DOCKETED	
Docket Number:	21-AFC-02
Project Title:	Willow Rock Energy Storage Center
TN #:	260808
Document Title:	Willow Rock Data Request Set 5 Response Report
Description:	N/A
Filer:	Kathryn Stevens
Organization:	WSP USA Inc.
Submitter Role:	Applicant Consultant
Submission Date:	12/23/2024 4:09:42 PM
Docketed Date:	12/23/2024

Willow Rock Energy Storage Center (21-AFC-02)

Data Request Response Set 5

Transmission Line Pole Location

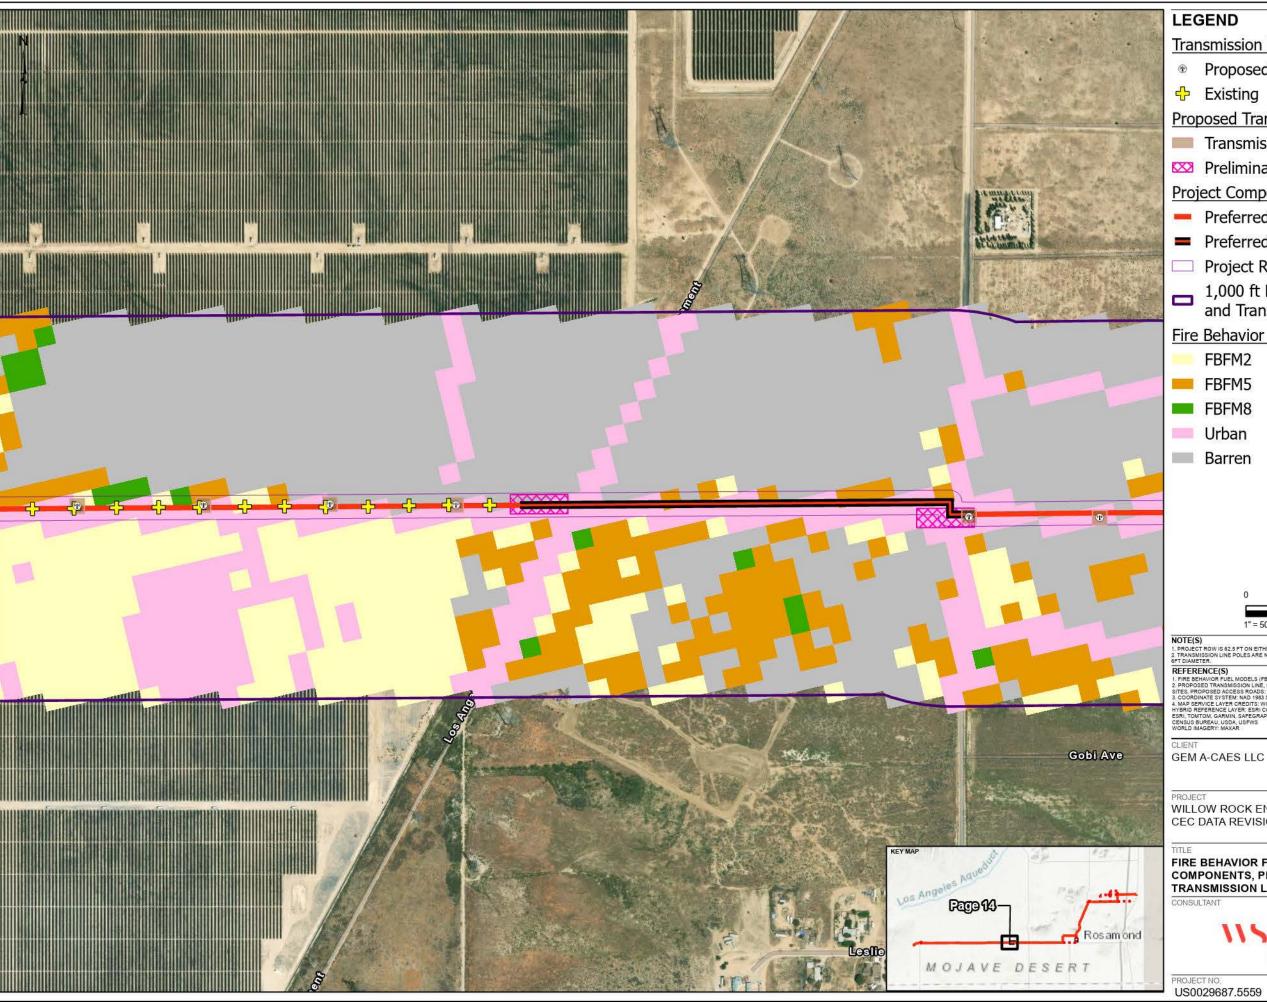
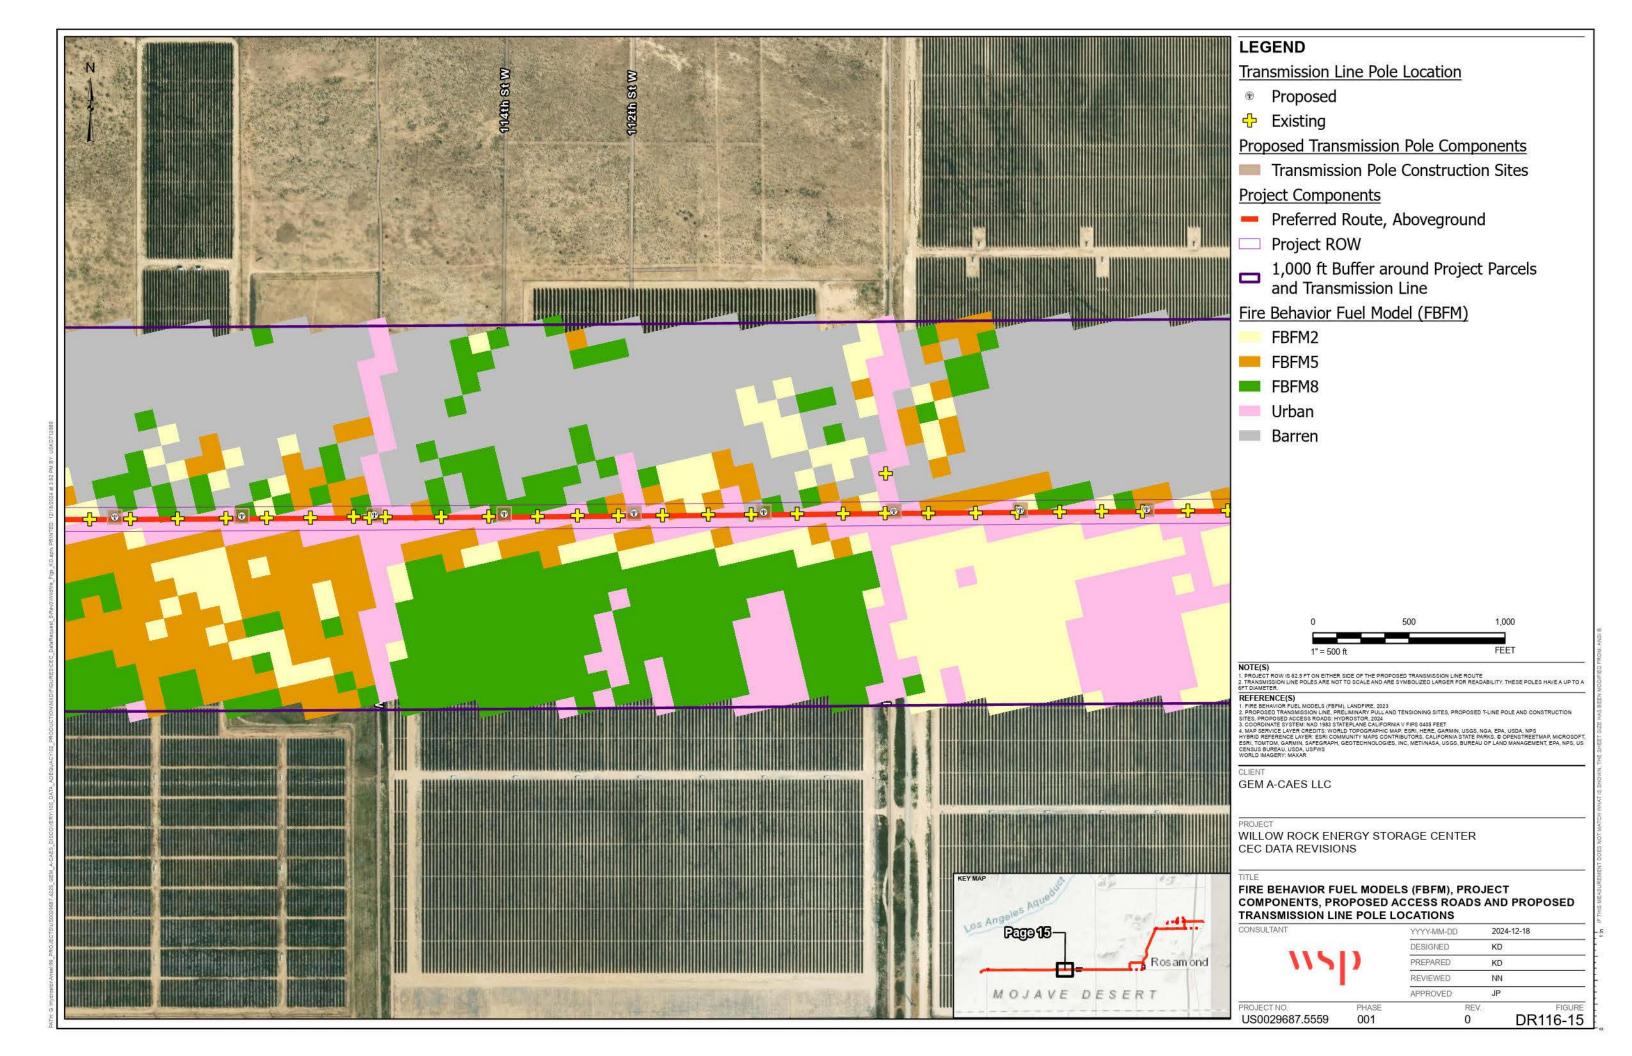
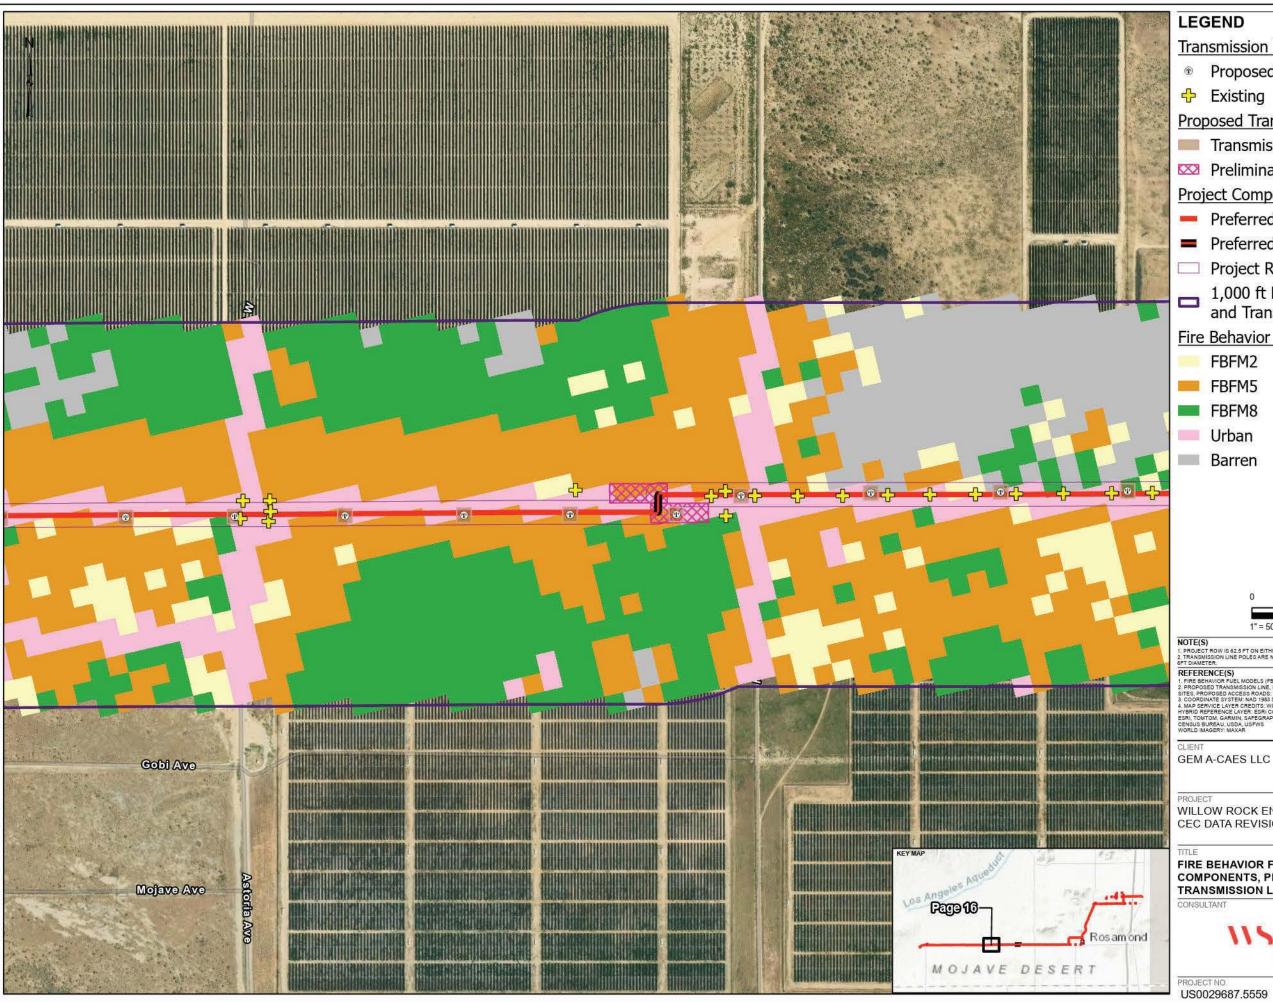
DR116: Provide a discussion and map that indicates how each identified Fuel Model relates to the project specifically and where they are in relation to each component of the project, including the transmission line.

Attachment DR116-1 provides a map showing the relevant fuel models in relationship to project components. The following describes how each fuel model geographically relates to the Project:

- Based on data from LANDFIRE, the fire behavior fuel models (FBFM) surrounding the transmission line and Project components are FBFM2, FBFM5, and FBFM8.
- FBFM2 dominates the area on the eastern side of the WRESC site.
- FBFM5 and FBFM8 make up the areas to the west of the WRESC site along Dawn Road.

- FBFM2 dominates the area surrounding Mojave Tropico Road.
- The majority of Rosamond Boulevard is surrounded by urban areas that do not include an FBFM, however FBFM2, FBFM5, and FBFM8 are dispersed along some sections of the road, with FBFM5 being the most dominant.
- The Whirlwind Substation is mostly surrounded by FBFM2, however, both FBFM5 and FBFM8 occur on the northeast side of the substation.
- The majority of existing and proposed transmission line poles are located in urban areas that are not classified with an FBFM.
- The majority of pull and tensioning sites overlap with FBFM2, FBFM5, or FBFM8.
